URBAN DESIGN COMMISSION APPLICATION

Address (list all addresses on the project site): 4725 Tradewinds Parkway
Title: Synbiotic Health

RE: 4725 Tradewinds Parkway
Urban Design Submittal / Upgrade

SYNBIOTIC
INTERIOR BUILD-OUT
4725 TRADEWINDS PARKWAY
MADISON, WI 53718

AS.1

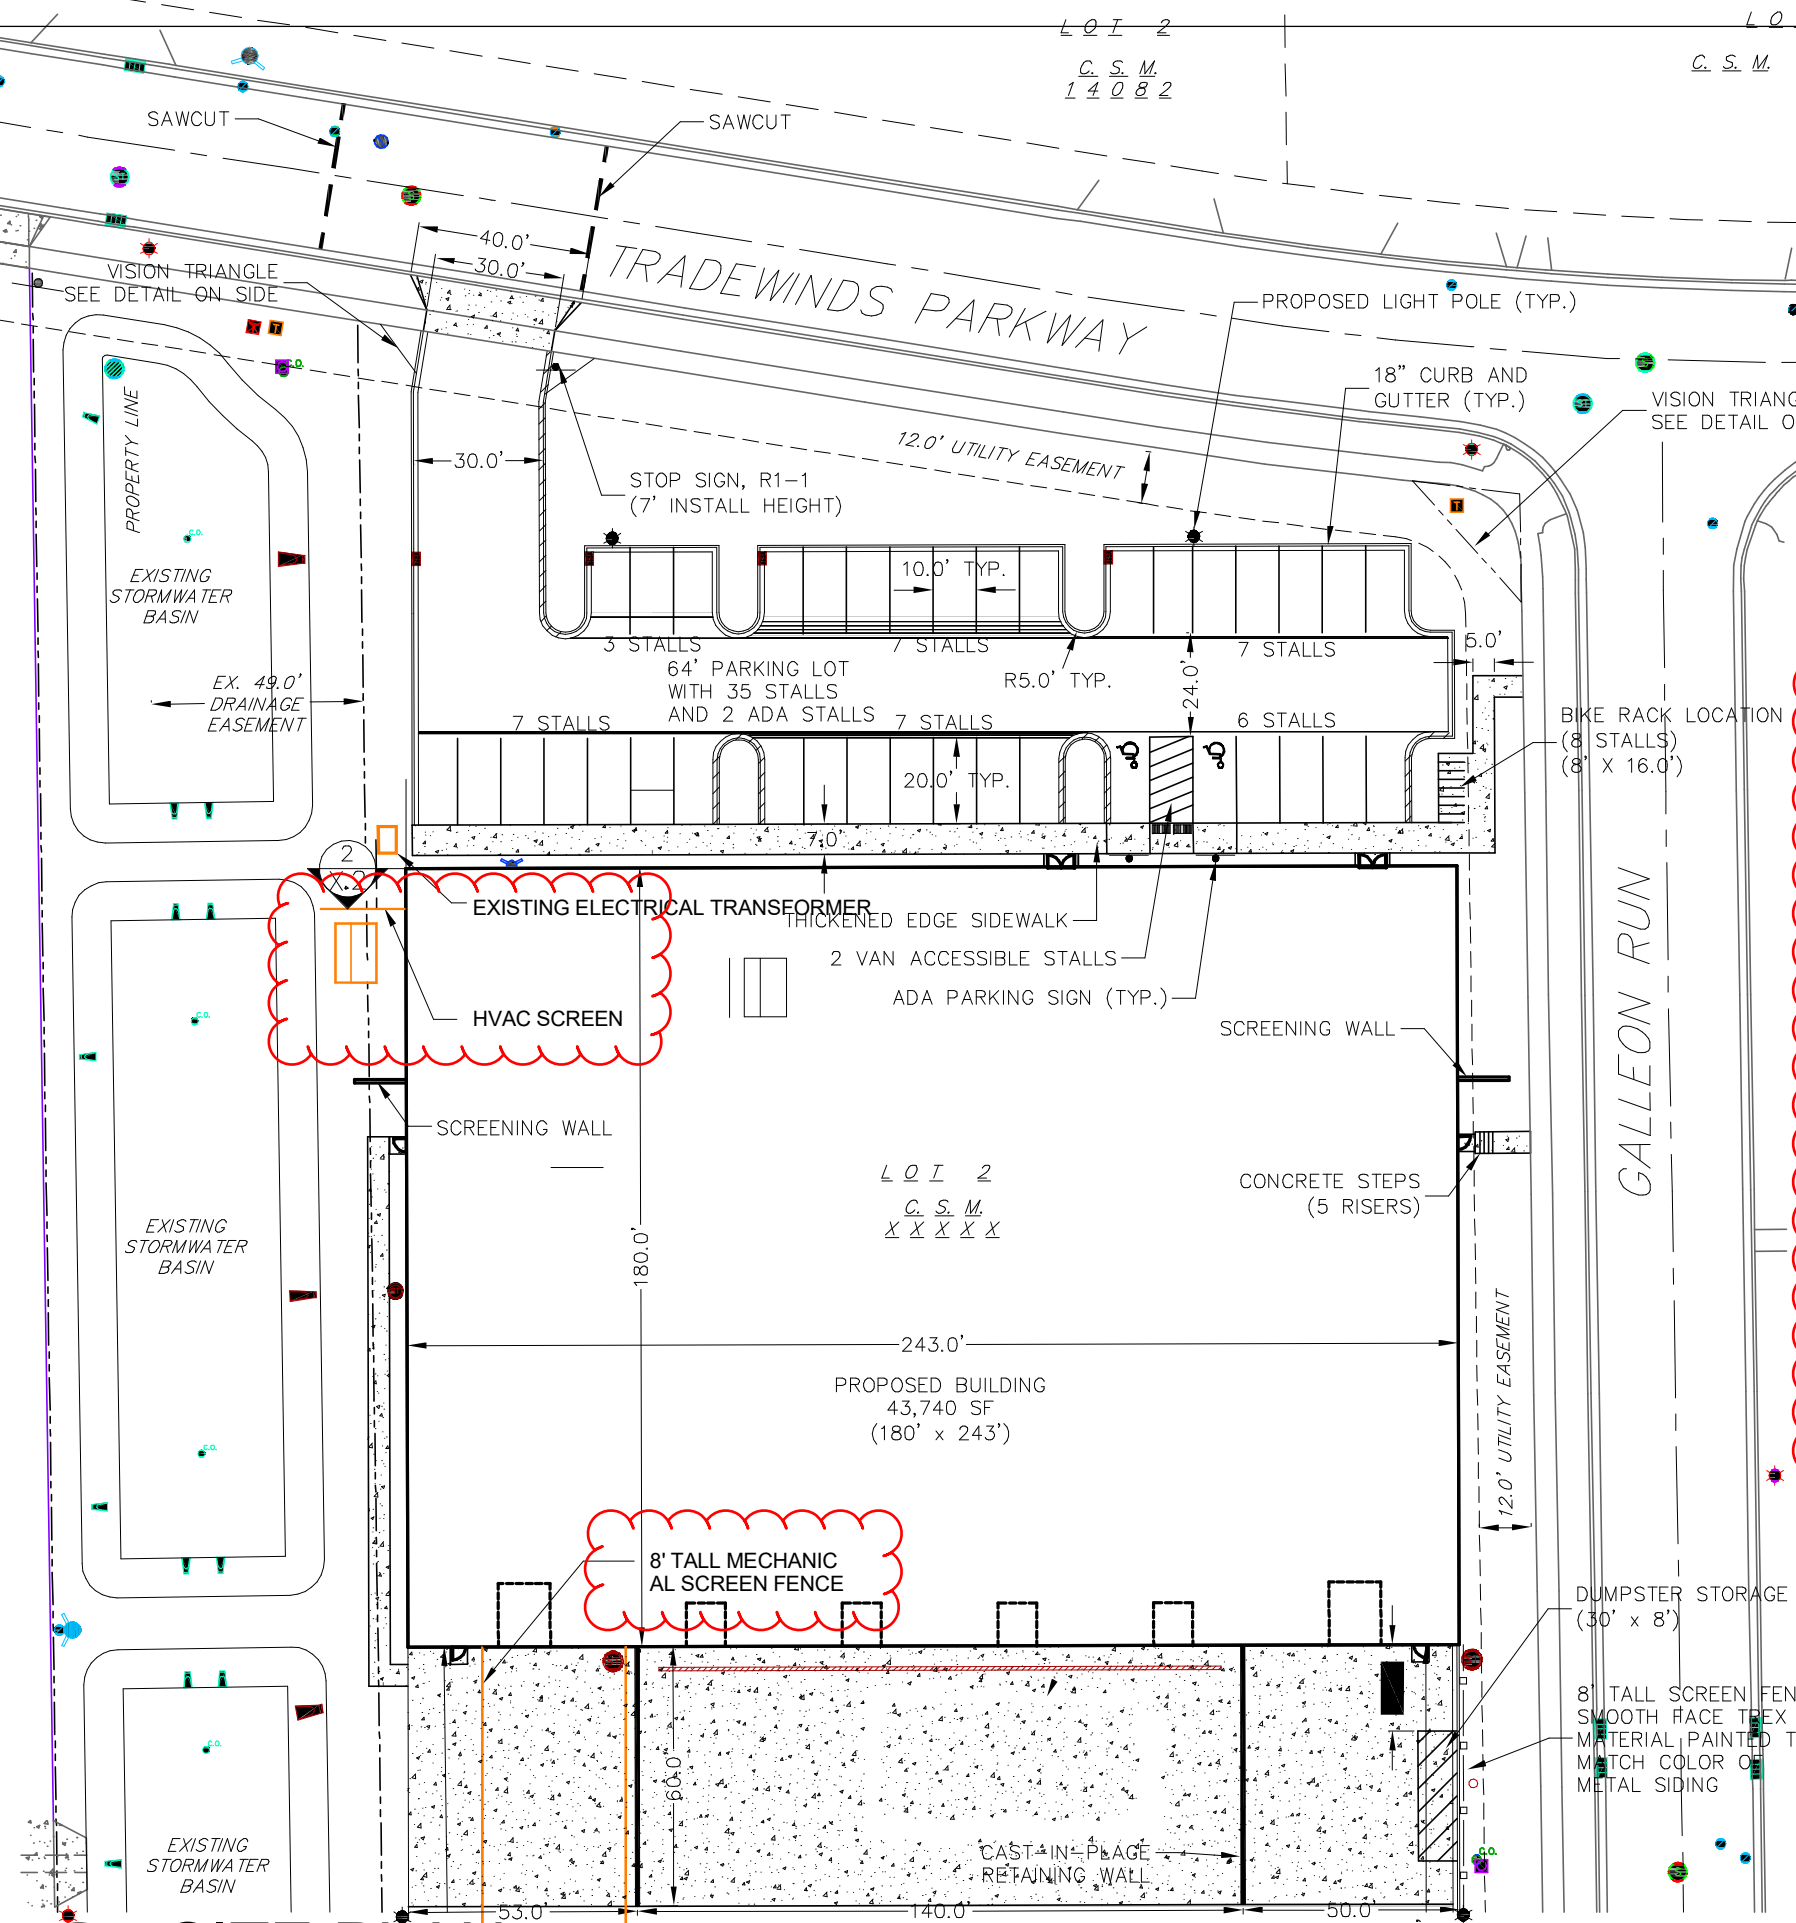
Site modifications (shown in attached plans) are minimal and include only the addition of screening fences for pad-mounted equipment. An hvac pad to be located on the west side of the building will be added and screened with both a complimentary metal screen fence, and evergreen trees as shown. Additional process equipment to eventually be located on the rear / south side of the building, on the existing concrete apron, will be screened with the same fence design.

PROPOSED ADD OF MECHANICAL SCREEN FENCE TO SITE PLAN 4/2023

LANDSCAPE

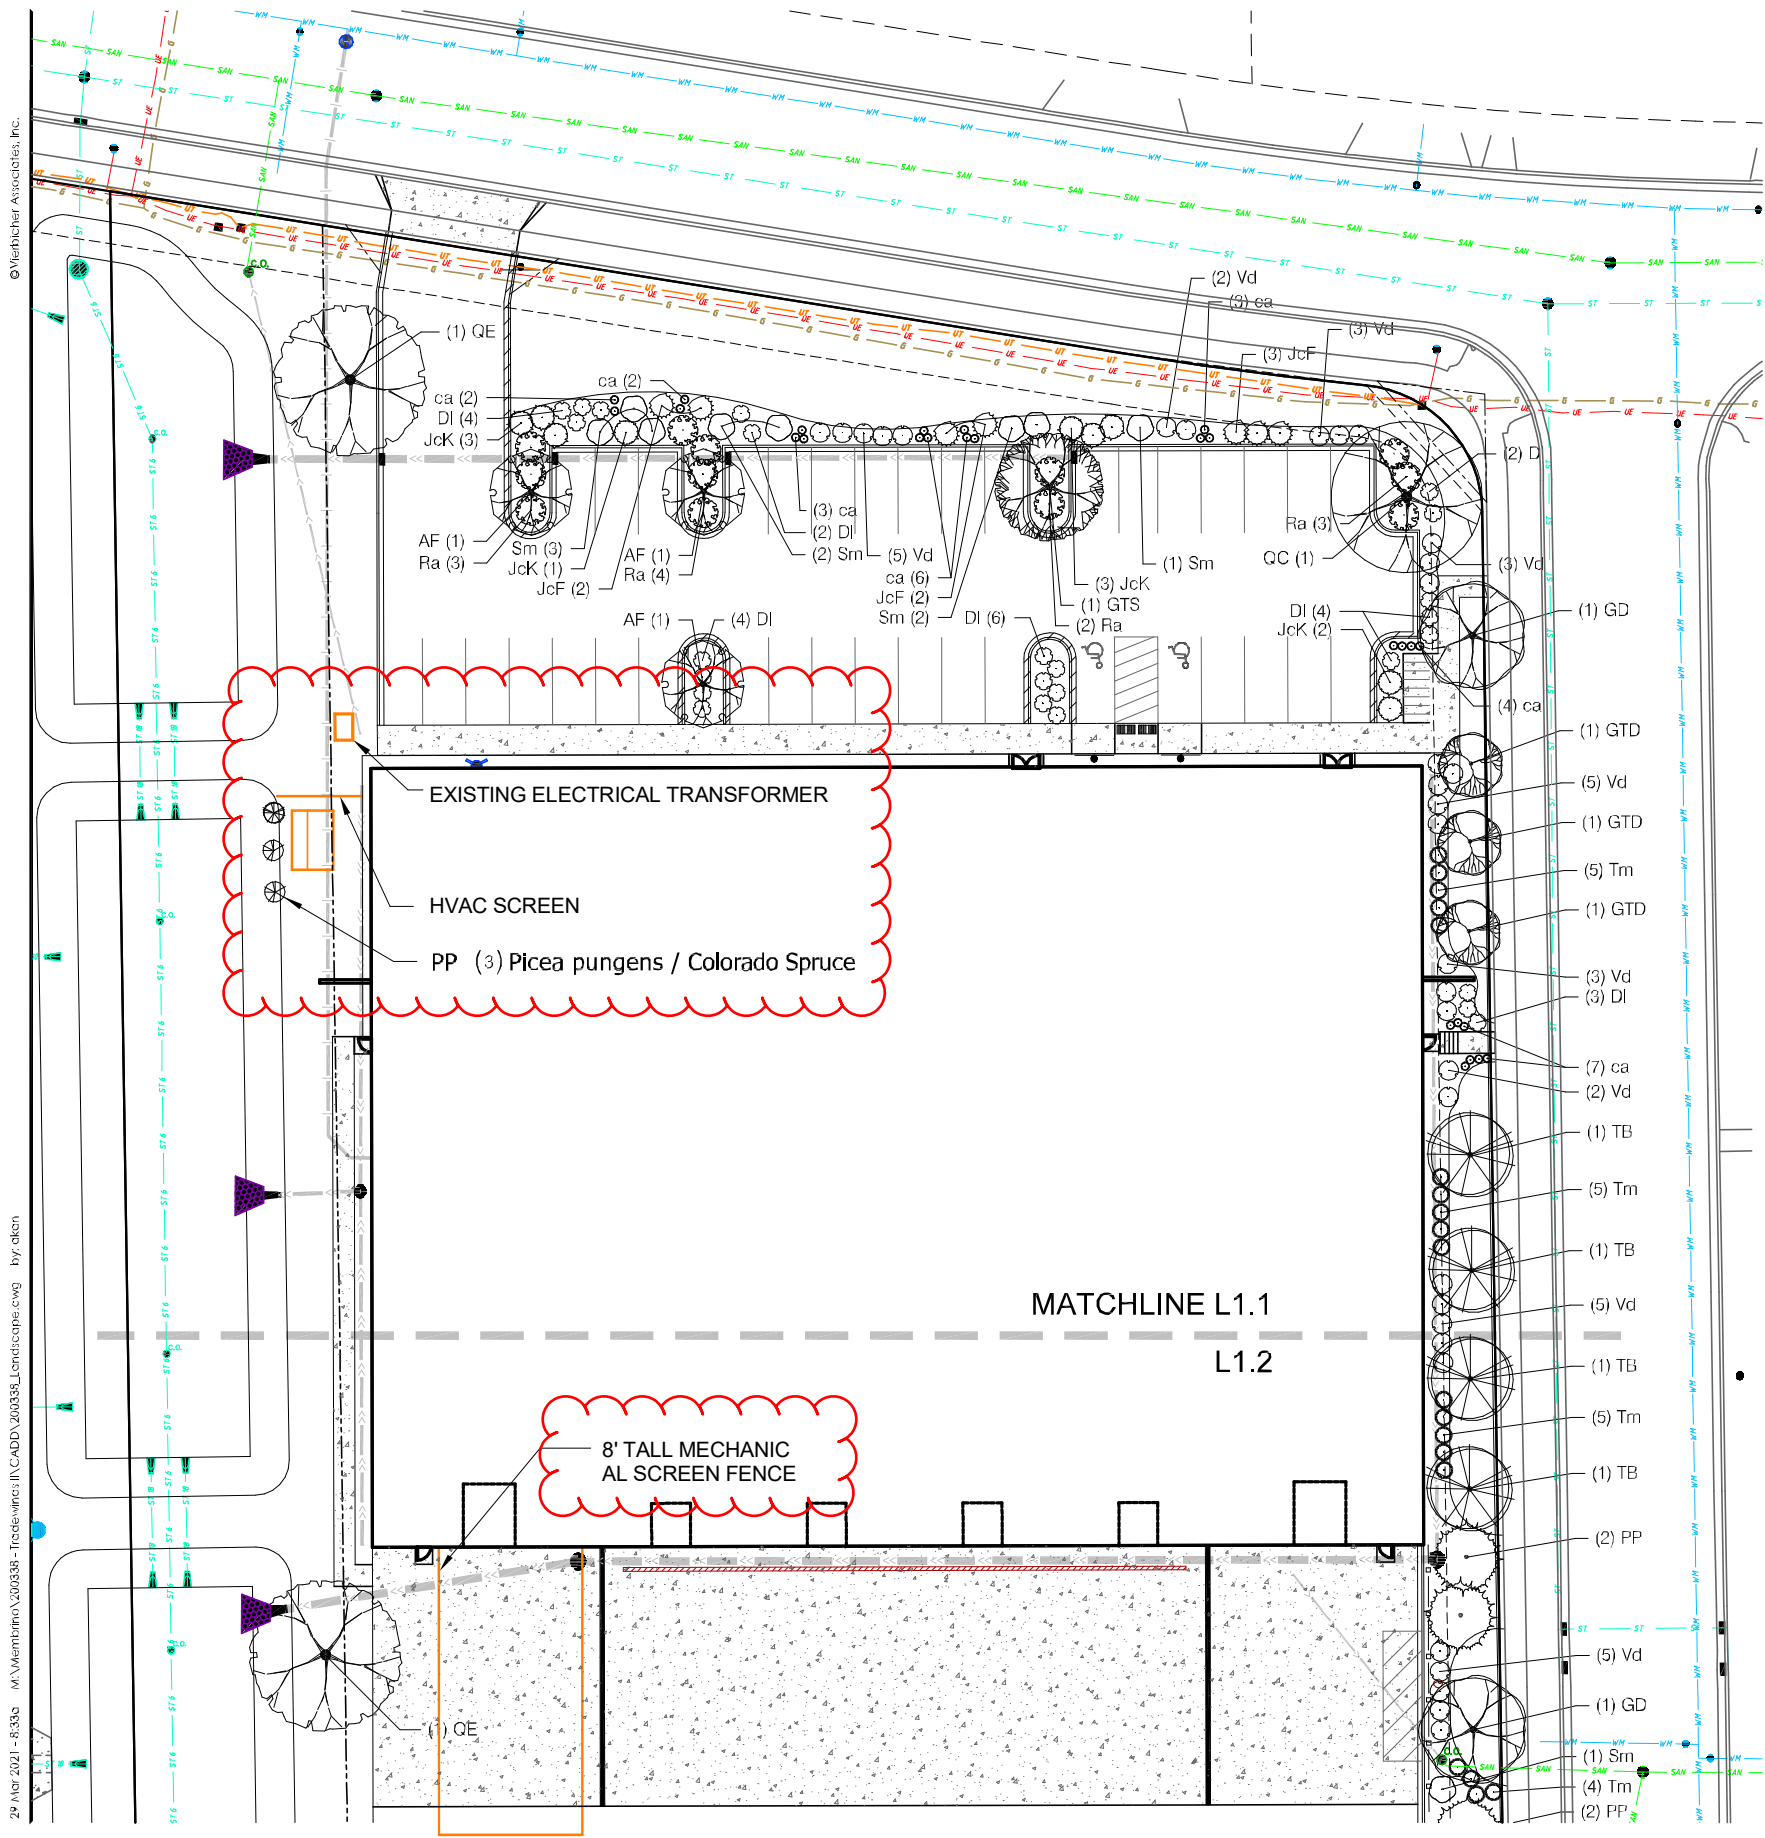
PROPOSED ADD OF MECHANICAL SCREEN FENCE AND EVERGREEN SCREENING. 4/2023

EAST ELEVATION

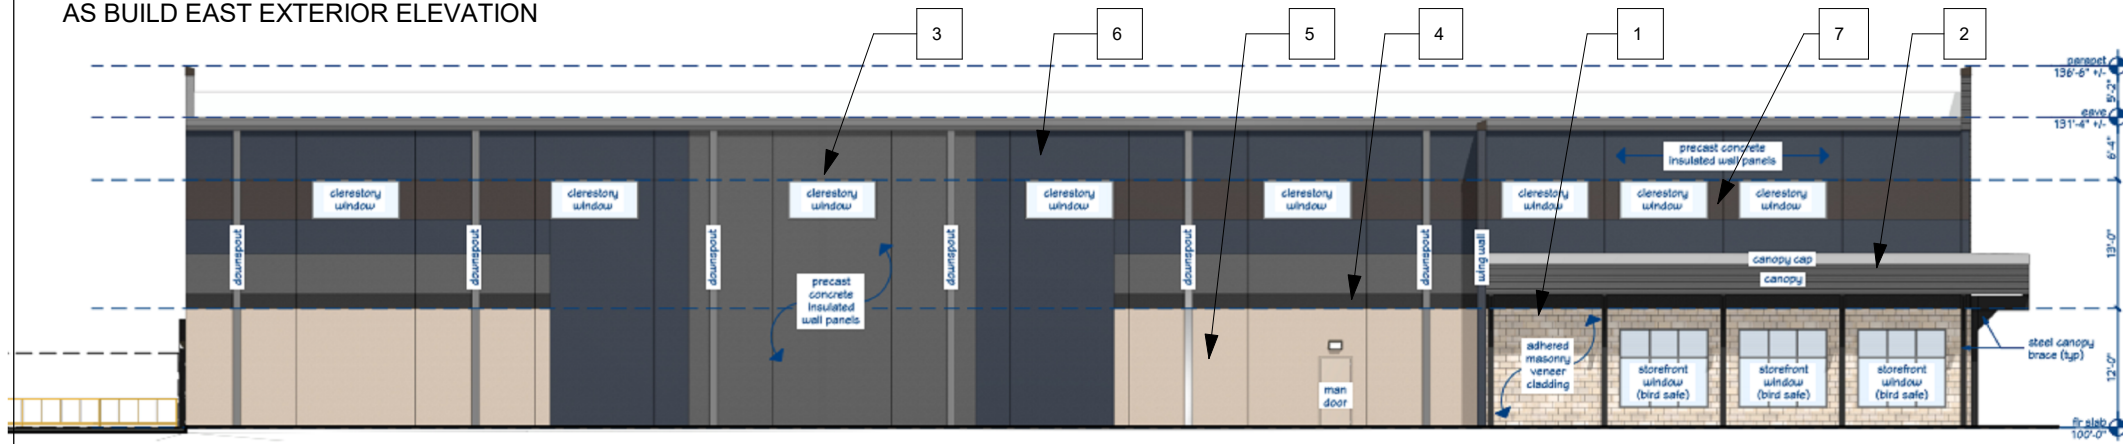
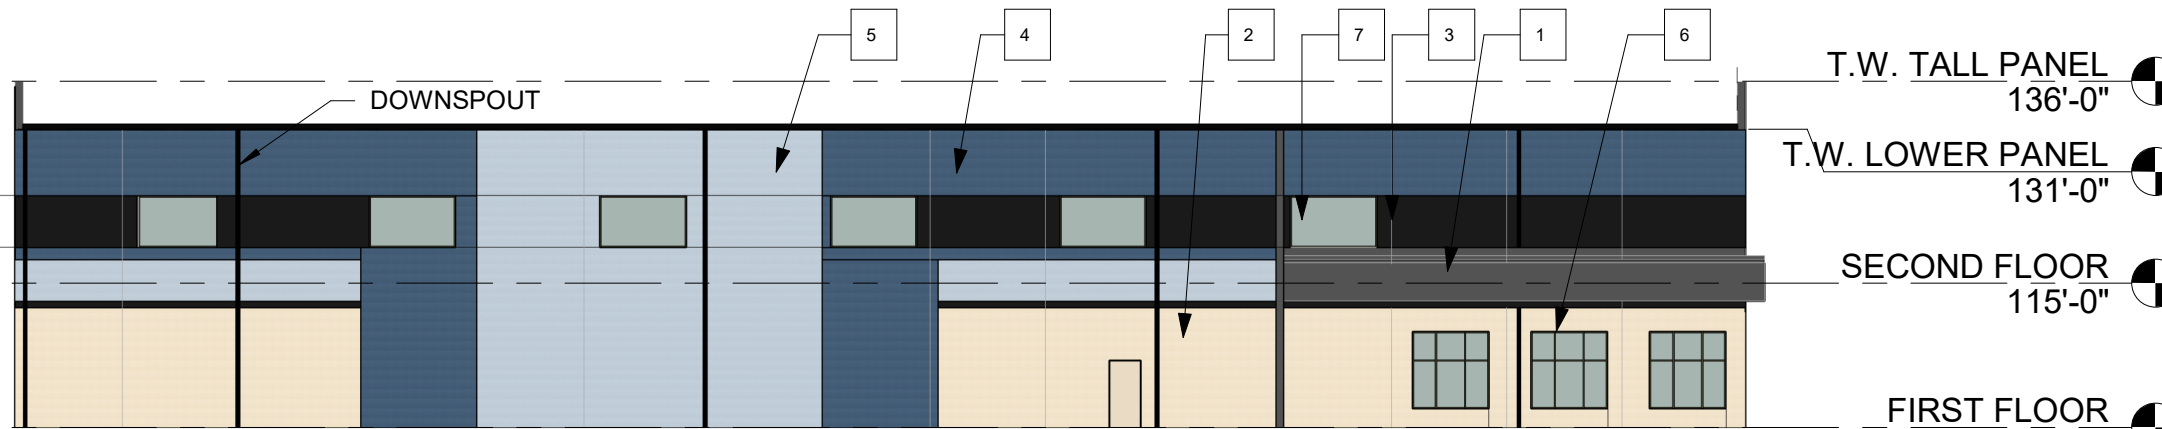
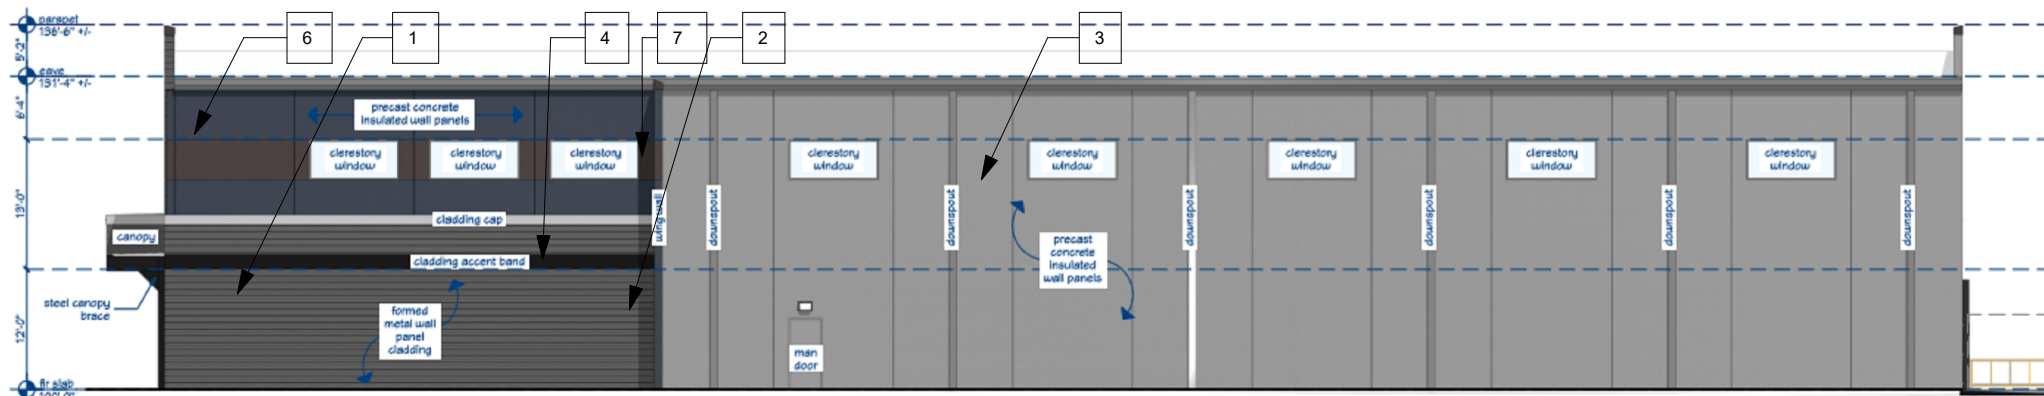
Our exterior shell design will include slight alteration of material placement, slight color change, windows to be relocated to locations previously identified as ‘future’, and mechanical unit

screening at grade. We are trying to remain true to the spirit of the original approval, but adding back the metal panels and window locations that were previously approved, as well as a canopy structure over the new tenant entry door.
